## ***TECHNICAL BULLETIN***

June 15, 2013  
No. 39

**SUBJECT: LEVER HEIGHT ON LEGEND LX  
AND LEGEND LUX**

**PRODUCTS AFFECTED: All Legend Regulators with MBS System**

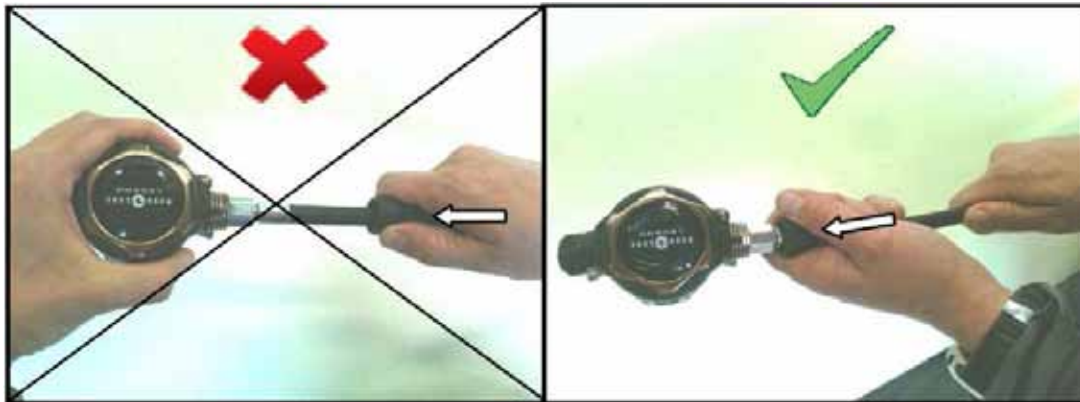
It was possible for the hose, which travels through the second stage swivel nut, to penetrate far enough into the second stage for the hose fitting to interfere with the crown orifice and turn it inwards. This, in turn would lower the lever.

The hoses that can allow this situation to occur have a swivel nut on them with smooth sides as shown here:

To eliminate this possibility in the future, we have corrected the hose, given it the p/n 129807, and have identified it by adding ribs to the swivel nut as seen here:

Hoses with this style swivel nut are not concerned with the above issue.
